277-289 WOODPARK ROAD SMITHFIELD NSW 2164

CIVIL WORKS

AMENDED PLAN

ALS
SMITHFIELD REDEVELOPMENT APPLICATION
277-289 WOODPARK ROAD SMITHFIELD LOT 1 IN DP1024505
COVER SHEET, DRAWING LIST
AND LOCALITY PLAN
CALIBRE DRG No.
COPP20170-DWG-C-0000
CLIENT DRG No.

CLIENT DRG No.

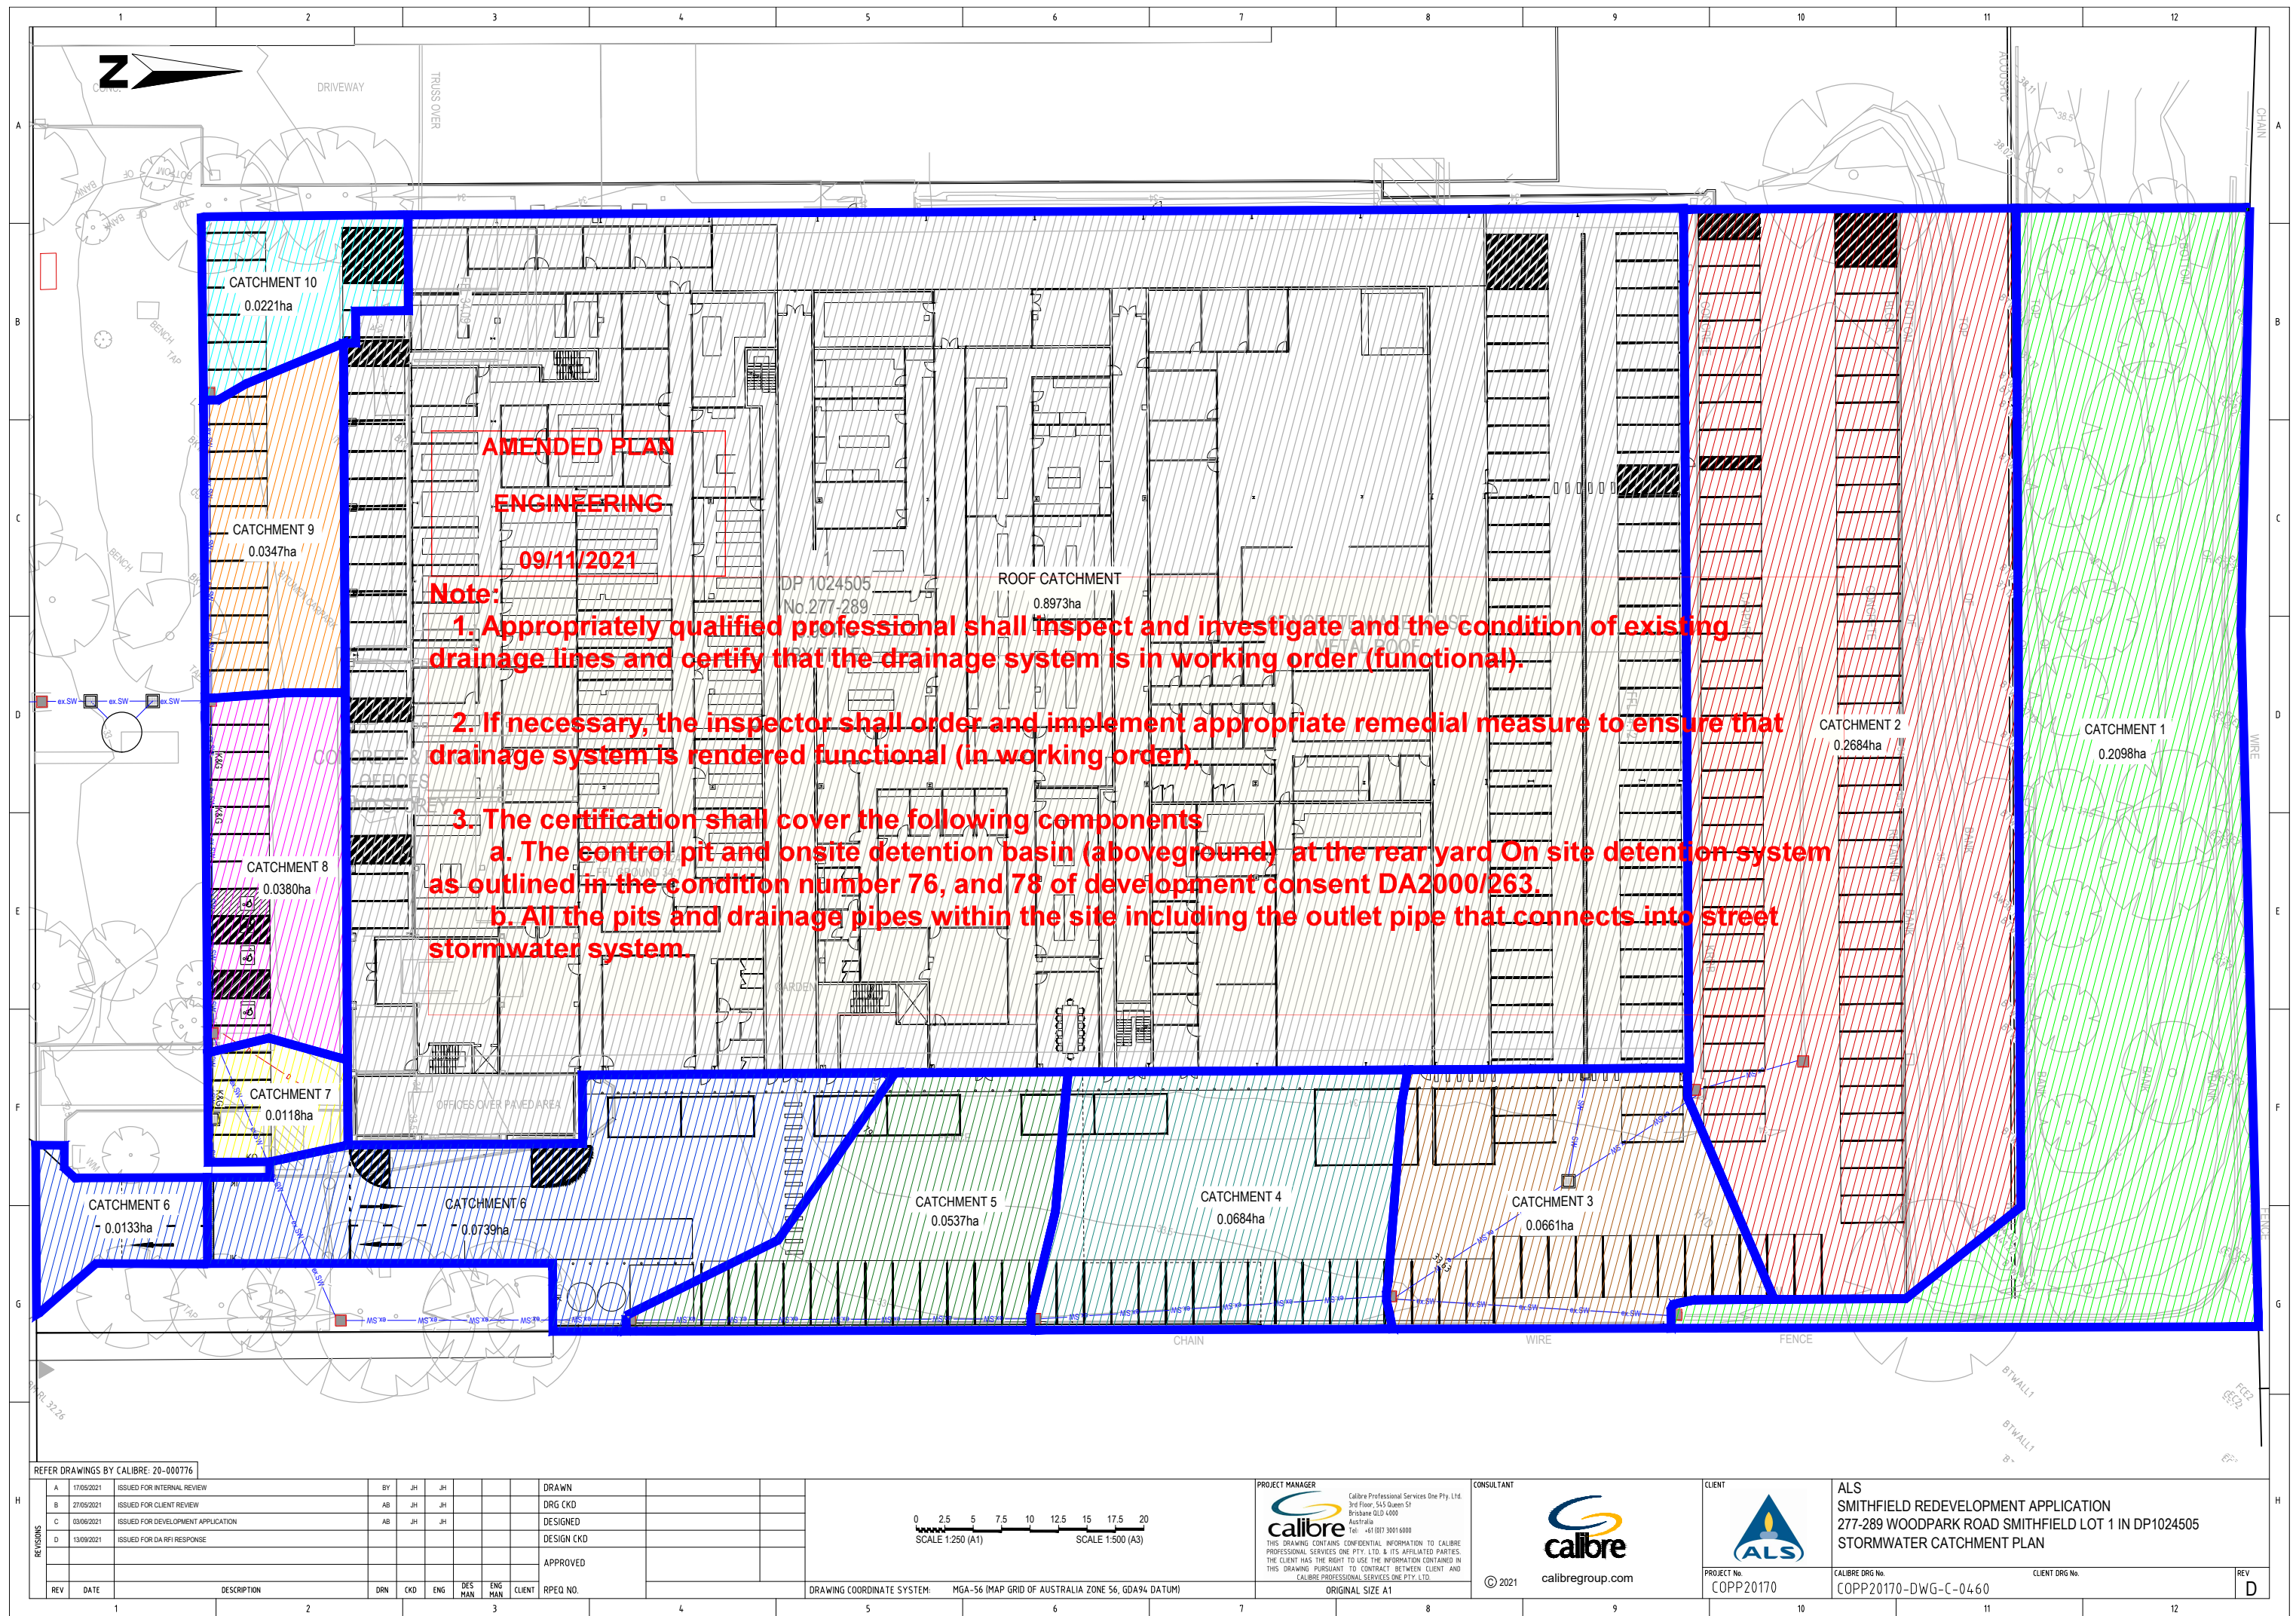
- Note:**
1. Appropriately qualified professional shall inspect and investigate and the condition of existing drainage lines and certify that the drainage system is in working order (functional).
 2. If necessary, the inspector shall order and implement appropriate remedial measure to ensure that drainage system is rendered functional (in working order).
 3. The certification shall cover the following components
 - a. The control pit and onsite detention basin (aboveground) at the rear yard On site detention system as outlined in the condition number 76, and 78 of development consent DA2000/263.
 - b. All the pits and drainage pipes within the site including the outlet pipe that connects into street stormwater system.

NOTE:
PROVIDE OCEANGUARD PIT BASKETS IN
ALL GRATED PITS DRAINING PAVEMENT
OR REAR LANDSCAPE AREAS
